SUBJECT: DUANE ARNOLD ENERGY CENTER – STAFF ASSESSMENT OF RESPONSE  
TO 10 CFR 50.54(f) INFORMATION REQUEST – FLOOD-CAUSING  
MECHANISM REEVALUATION (CAC NO. MF3686)

STAFF ASSESSMENT BY THE OFFICE OF NUCLEAR REACTOR REGULATION

RELATED TO FLOODING HAZARD REEVALUATION REPORT

DUANE ARNOLD ENERGY CENTER

Figure 3.2-2. Comparison of 1-h, 1-mi<sup>2</sup> LIP Cumulative Precipitation Depth Based on HMR 51/52 and ssPMP Evaluation Methods (NextEra, 2014a, Figure 4-5).

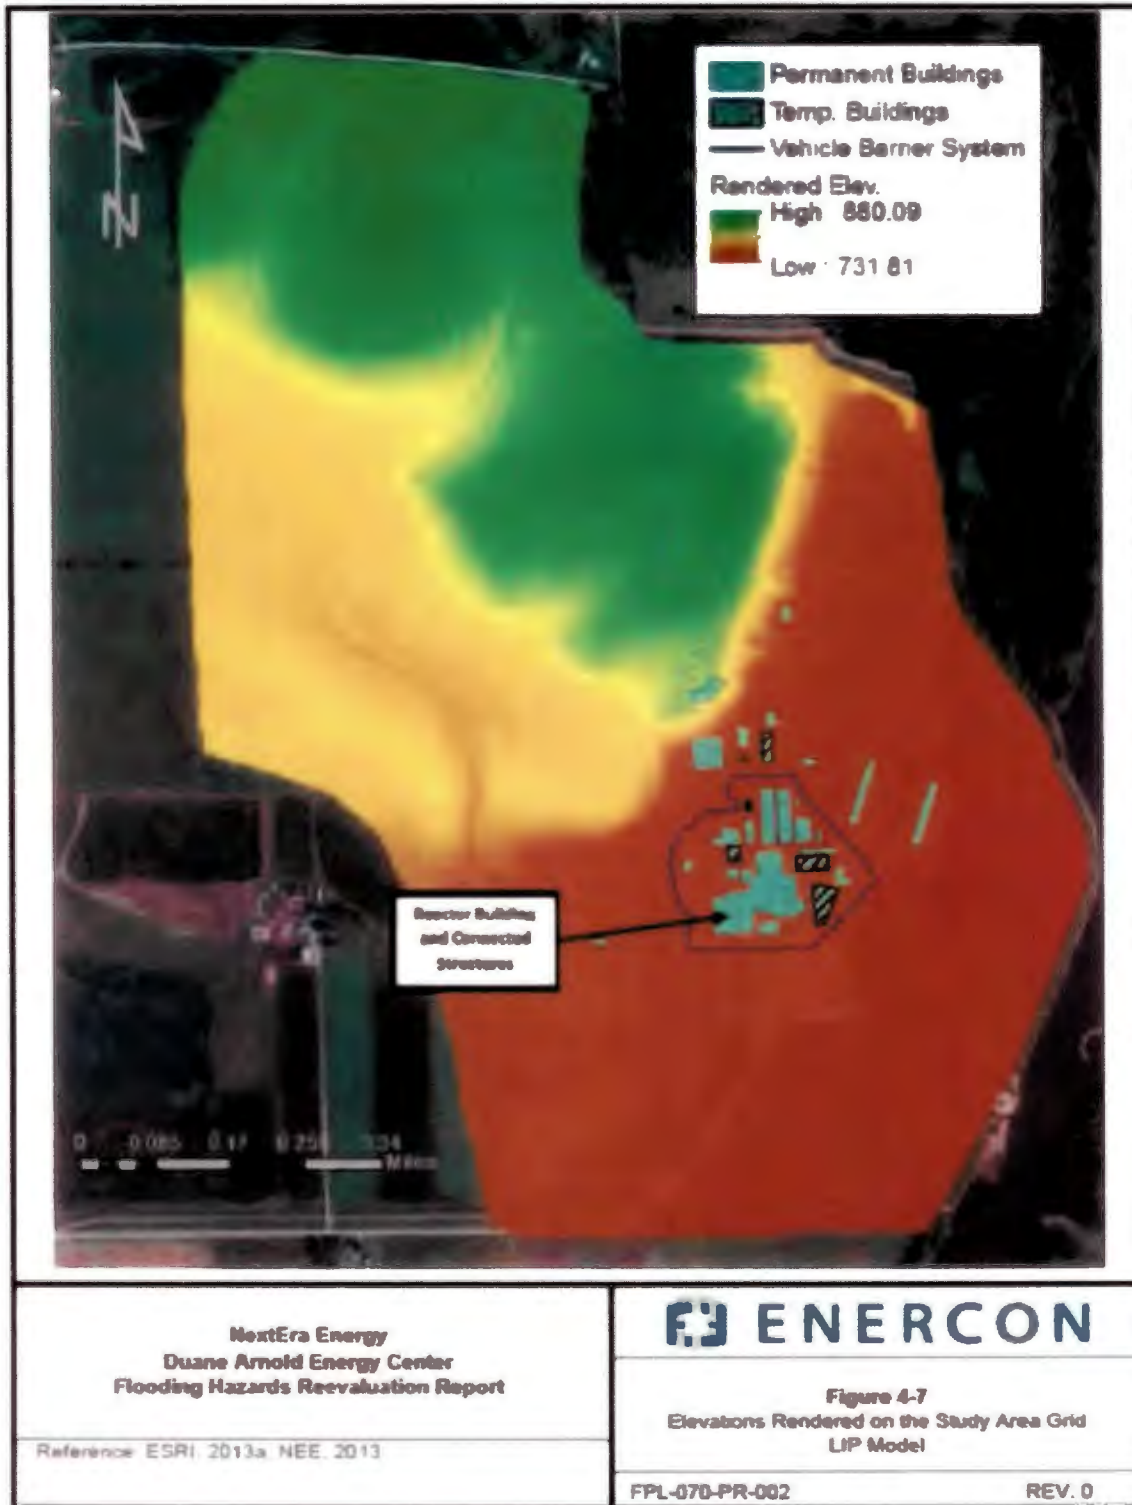
The licensee used the HMR guidance to distribute the 5-minute (min), 15-min, and 30-min precipitation depths for 1-mi<sup>2</sup> areas. The licensee-estimated 1-h, 1-mi<sup>2</sup> PMP depths for both the HMR and site-specific methods are reported in Table 3.2-1; the cumulative precipitation graphs associated with these two methods are shown in Figure 3.2-2. For the ssPMP, the licensee tested three peak rainfall distribution scenarios: the front-loaded; center-loaded; and end-loaded hyetograph shapes to find a bounding scenario. The licensee's analysis determined that the site-specific, end-loaded PMP temporal distribution produced the highest water depths at the Duane Arnold site; therefore, the licensee used this case as input for the final LIP flood hazard estimation.

In order to determine the significance of an ssPMP-derived number on estimated flood depths at the Duane Arnold site, the staff independently evaluated the sensitivity of the licensee's FLO-2D model to that scenario using the rainfall value obtained from HMR-52 (NOAA, 1982). As noted above, the HMR-based PMP value was 17.9 in. or about 21 percent larger than the licensee's ssPMP value. A scenario-based sensitivity analysis of flooding due to an HMR-derived LIP flood estimate was performed using the licensee's FLO-2D computer model. Aside from changing the PMP value, no other changes were made to the LIP model. The results of staff's sensitivity analysis show that the WSEs estimated using the HMR-based event were only slightly higher than the WSEs estimated using the licensee's ssPMP-based event. Differences in the respective WSE estimates varied from location-to-location within the powerblock, however the maximum differences were on the order of +0.06 ft. In light of these small differences, the staff determined that it was not necessary to review the manner in which the licensee's ssPMP estimate was derived. Correspondingly, the staff concluded that the licensee's ssPMP values were reasonable to use in the LIP runoff analysis discussed below.

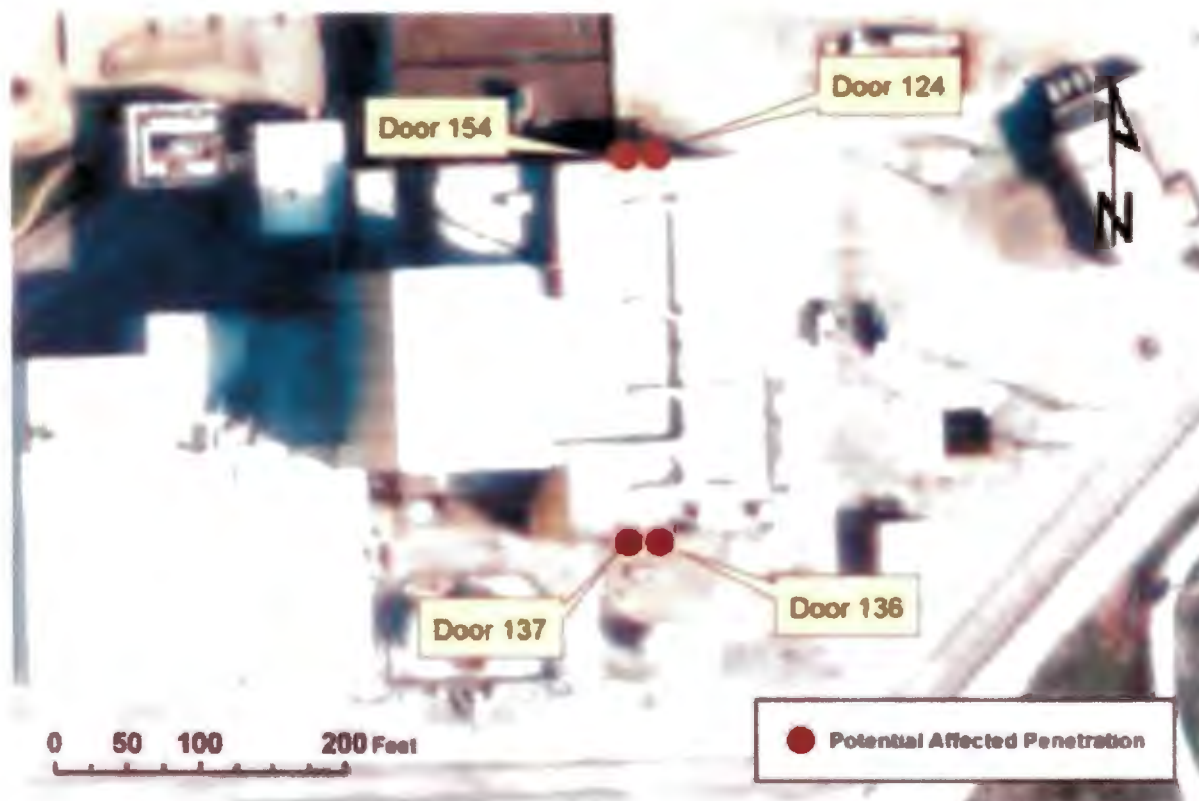
The staff observed that no outflow elements were specified along the boundary of the FLO-2D model (i.e. the boundary of the modeling domain was treated as a vertical wall of infinite height as shown on Figures 3.2-4a and 3.2-4b). The staff conducted a sensitivity analysis to evaluate the significance of this boundary condition specification by introducing outflow elements along one portion of the boundary based on the recommendations in the *FLO-2D Reference Manual* (FLO-2D Software Inc., 2009); these outflow elements were added in the vicinity of the intake structure located along the Cedar River (Figure 3.2-4c). The staff found that the differences in maximum flood depths was coincident with the locations of the four Turbine Building doors listed in Table 3.2-2, but these differences did not exceed the reported values.

Figure 3.2-5. Turbine Building Door Locations were the CDB is exceeded due to LIP (NextEra, 2016a, Figure 4-9).

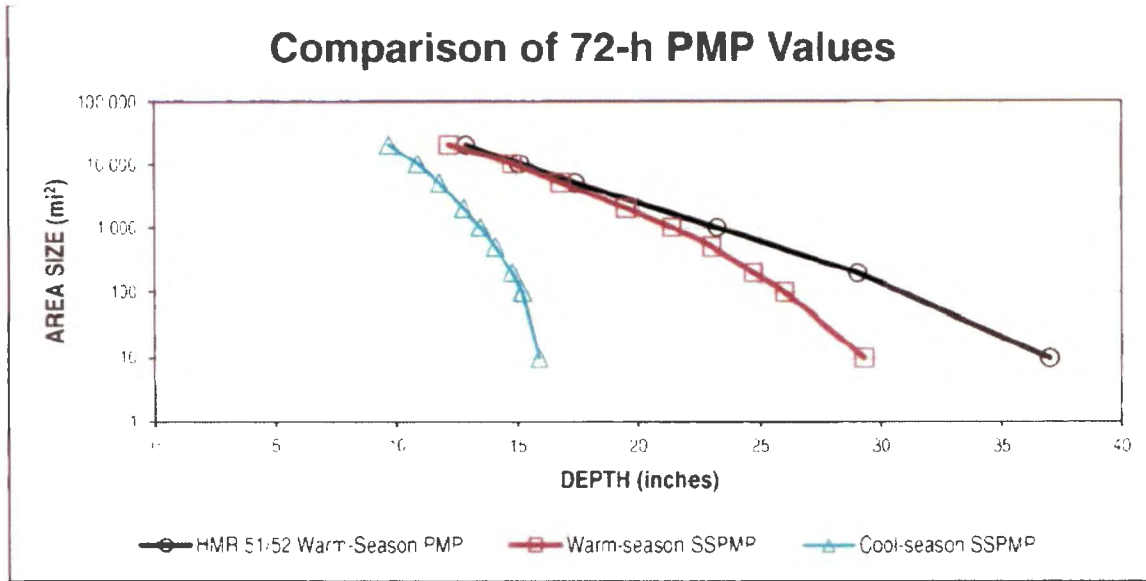
However, the licensee did not provide the FED values for the time for the LIP event to reach the maximum reported WSE at the impacted door locations (Table 3.2-3), as well as the recession time for water egress from those locations. The licensee is expected to develop FED parameters for these flood-causing mechanisms in order to conduct the MSA<sup>7</sup> and focused evaluations or revised integrated assessments. The NRC staff will review these FED parameters as part of future additional assessments of plant response, if applicable to the assessment and hazard mechanism.
